# Product Change Notification

Product Change Notification: PCN-23-175091

RY series relay Cover color Change

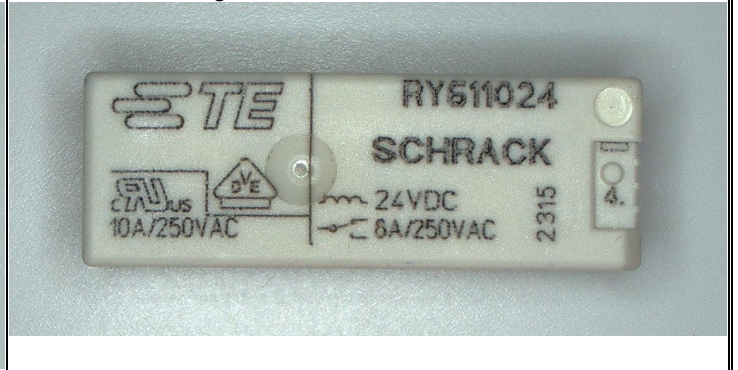
The following part numbers are being modified by changing the outside cover color from orange to natural. While both materials have the same characteristics, the same tests according to UL, VDE, CQC and HazLoc are passed. The Relay form (dimensions), features and ratings keep unchanged.

Cover color before change

Cover color after change
